Re: Amended Jeths Drain (2024)

The Jeths Drain Report, originally dated May 7, 2024, is proposed to be amended as a result of a landowner changing their request from a road design access culvert to a standard access culvert. The Landowner also requested that the new culvert be installed at the westerly limit of their property. It is therefore proposed to be combined with the adjacent access culvert. All costs associated with this work will be assessed to property requesting the change and will not be assessed to the Landowners in the watershed. This report highlights the proposed changes in “italics” and “red” font.

DRAWING NAME:
Jeths Drain Plan

DRAWING NAME:
Jeths Drain Profile

TOWN of AMHERSTBURG
JETHS DRAIN
PLAN

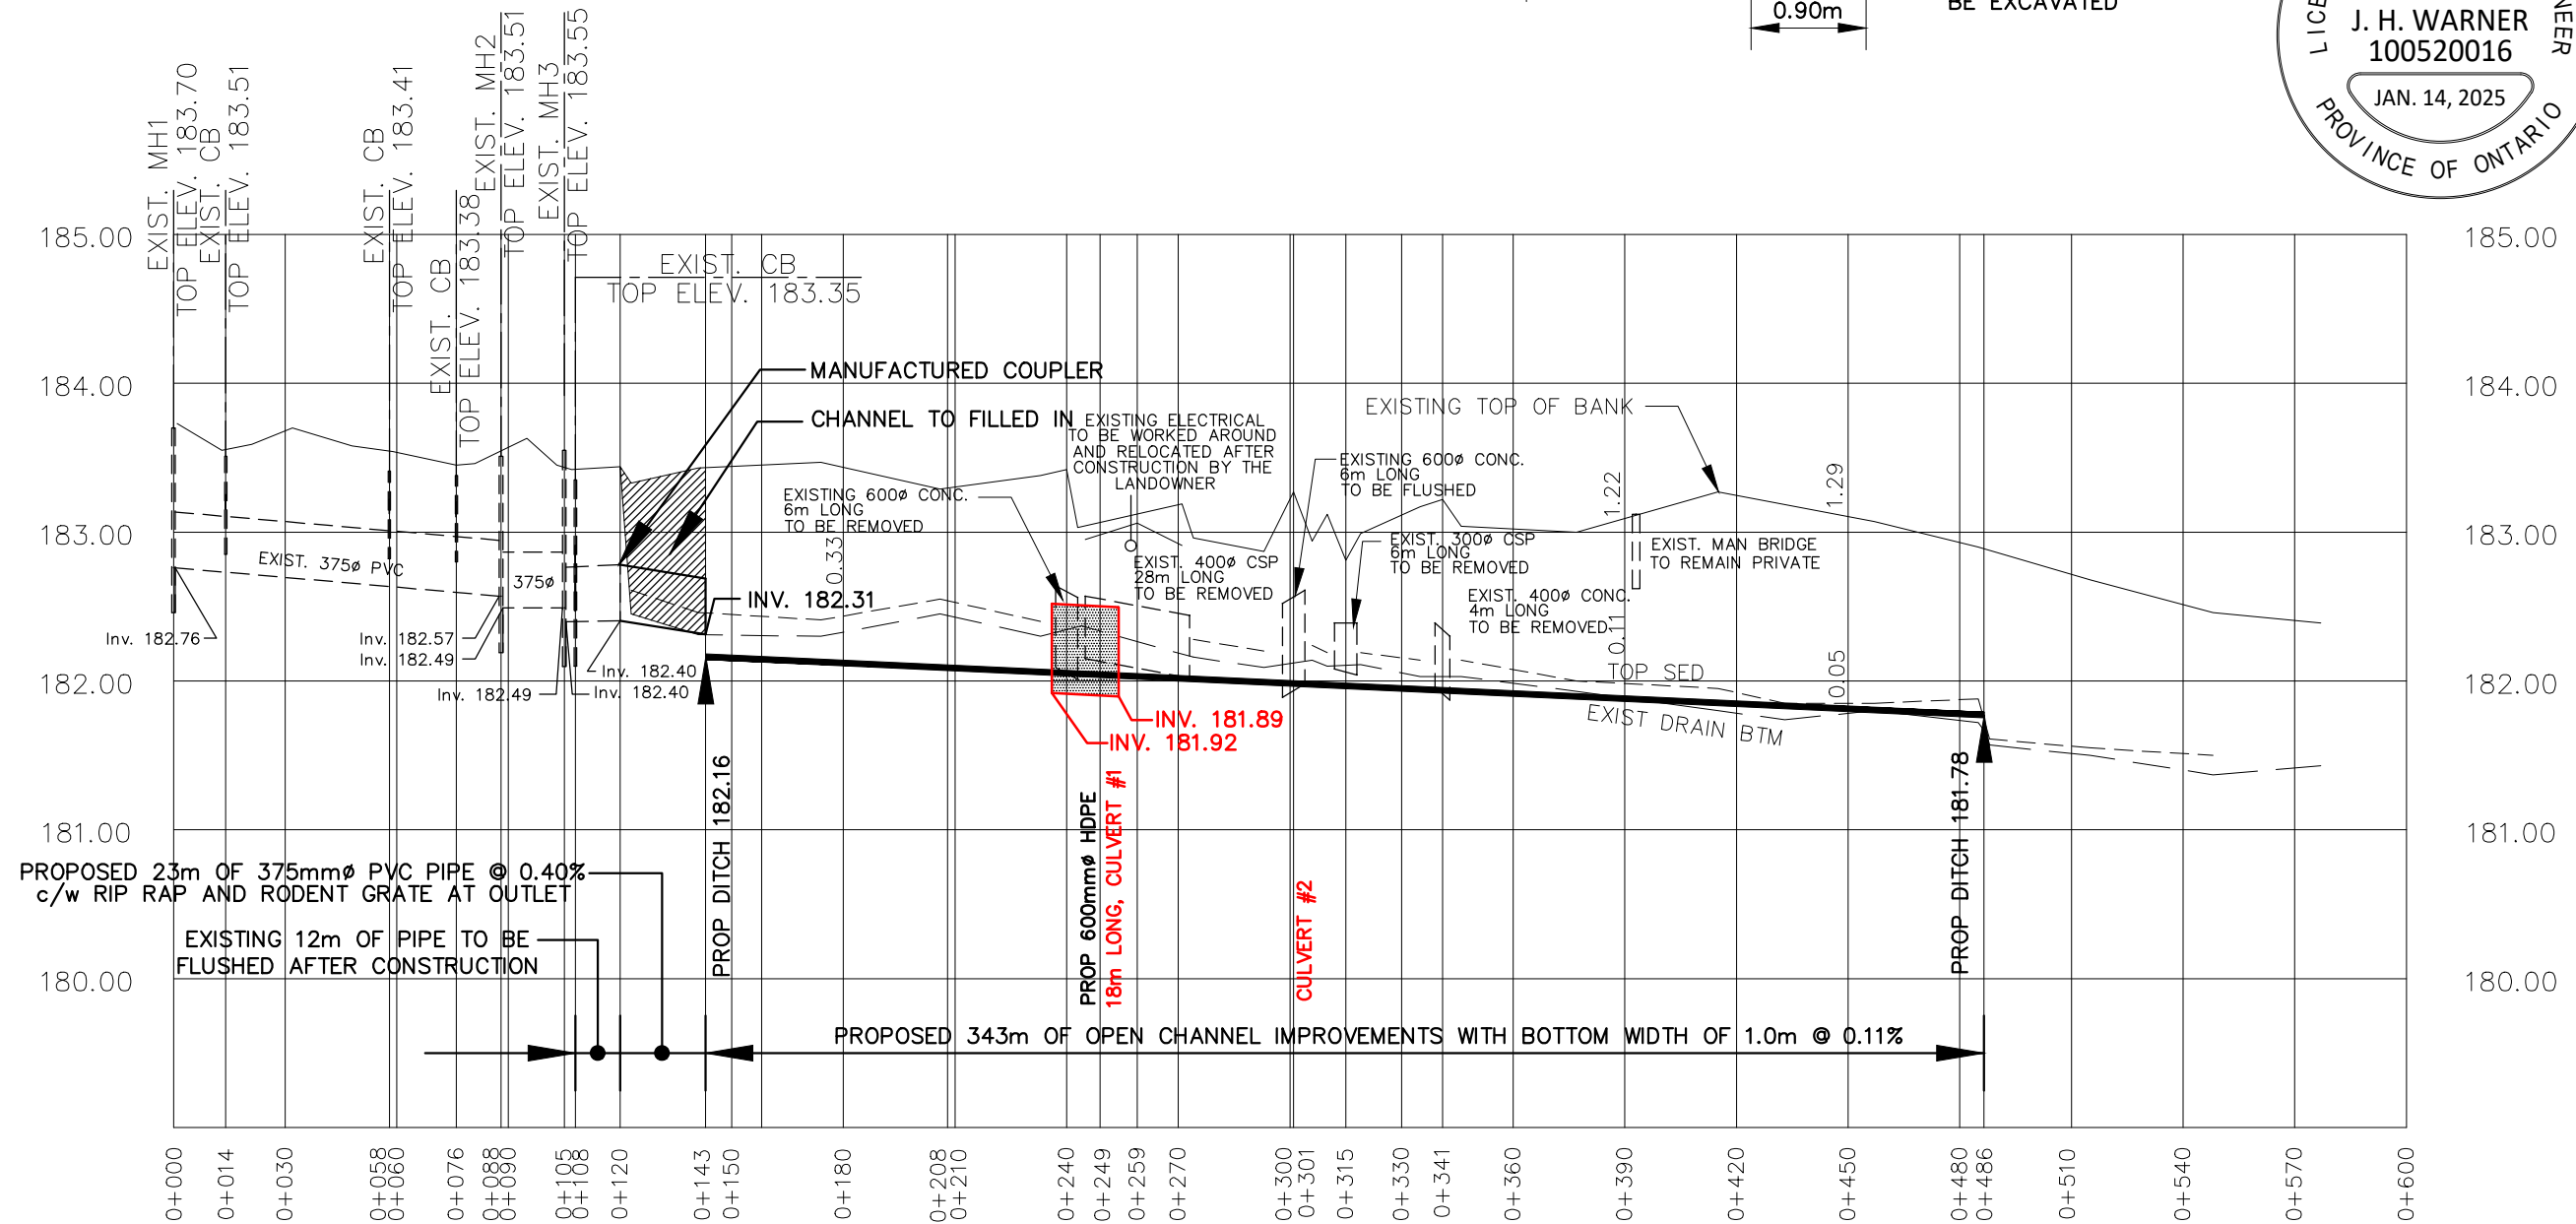
The Landowner with L.I.N. 13 (Culvert No. 1) requested that their culvert be sized and lengthened in order to support a road standard design and that the location be near the east limit of the property. *As outlined above this request was rescinded and the culvert has been requested to be a standard access culvert and near the west limit of the property.*

The Landowner with L.I.N. 14 (Culvert No. ~~2~~ *Now combined as Culvert No. 1*) requested that their culvert be reduced in length to provide a 6m top width and that it be located at the easterly edge of their property. It was discussed that the Landowner will have the electrical wire relocated once the culvert is removed.

The Landowner with L.I.N. 15 (Culvert No. ~~3~~²) requested that their culvert be removed if it is determined to be in poor shape once it is flushed.

The Landowner with L.I.N. 19 (~~Culvert No. 4~~) requested that their existing culvert be removed.

TOWN of AMHERSTBURG
JETHS DRAIN
PROFILE

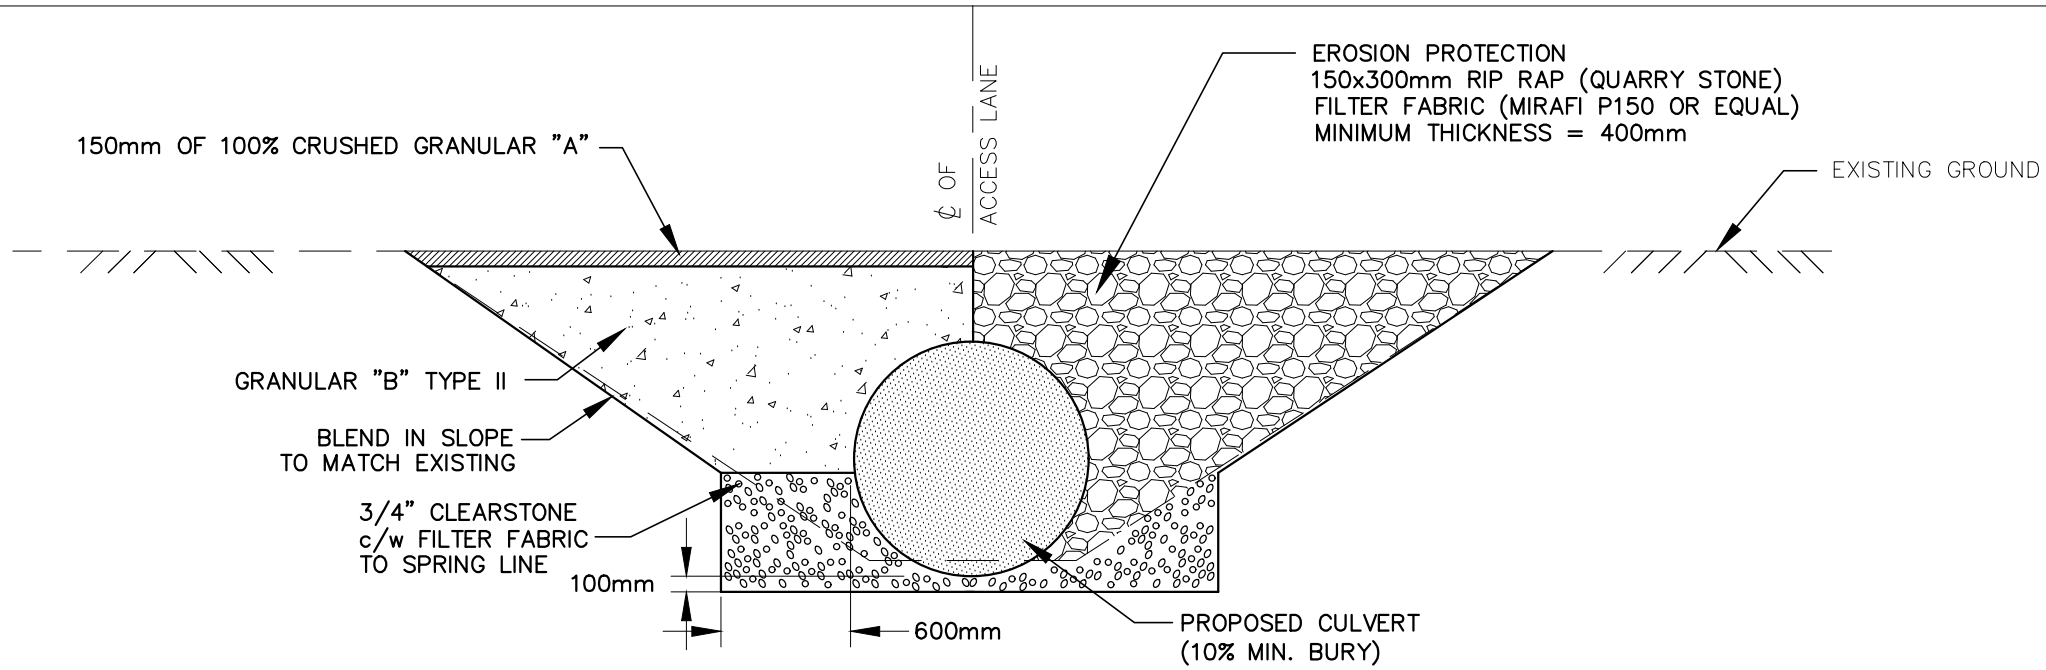
~~Culvert No. 1 has been designed to provide outlet for a 1 in 25-year storm event as it will potentially serve as a road culvert in the future.~~

The culverts shall be maintained and repaired with a culvert length required to have a 6m top width and designed to a 2-year storm event. With the culverts shown on the profile, including rip rap end walls for ~~Culvert No. 2 and concrete blocks for~~ Culvert No. 1, they shall be assessed in the following manner:
